Transmission Expansion Advisory Committee FirstEnergy Supplemental Projects

January 7th, 2025

Change to the Existing Projects

JCPL Transmission Zone M-3 Process Middlesex 230 kV Switching Station

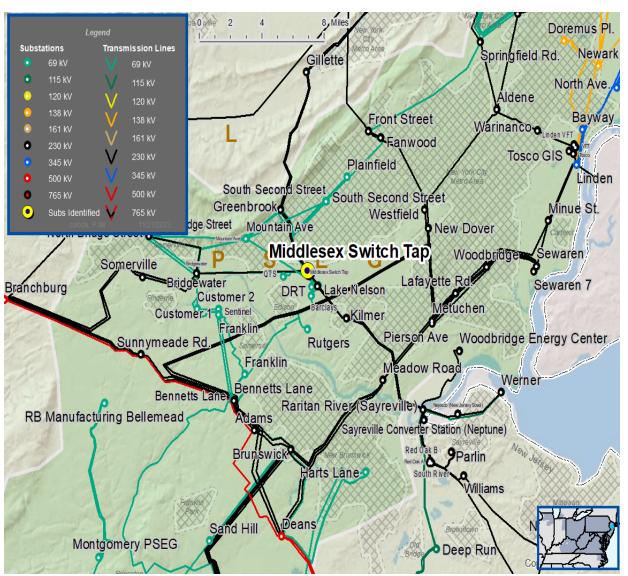
s3261.1: Originally presented in 12/5/2023 and 02/06/2024 TEAC meetings. Changes are marked in red

- The current configuration of the I1023 Line is a three-terminal line with terminals at Lake Nelson (PSEG), Bridgewater (PSEG), and Gillette substations.
- The Middlesex Switching Station serves as the connection point to the rest of the I1023 Line for the Bridgewater section. The I1023 Line is one of only a few lines that interconnect the Jersey North and Jersey Central regions.
- Over the past five years, the Gillette-Lake Nelson-Bridgewater I1023 230 kV Line experienced two unscheduled outages

- Convert the existing Middlesex 230 kV Switching Station to a three (3) breaker ring bus.
- Upgrade limiting switches and TL drops at the Middlesex 230 kV Switching Station.

- At Bridgewater Switch and Lake Nelson Sub:
 - Replace primary and backup I-1023 line relays with new relays.
 - Remove all existing Power-Line Communication (PLC) equipment and line traps in switchyard and the PLC equipment in the control house.
- Between Bridgewater Switch and Middlesex (FE):
 - Install new 96-strand OPGW (approximately 6.18 miles) from Bridgewater to Middlesex (FE).
- Between Lake Nelson Sub and Middlesex (FE):
 - Install new ADSS from Middlesex (FE) to intercept and splice into the existing 230kV GBLN circuit ADSS fiber cable.
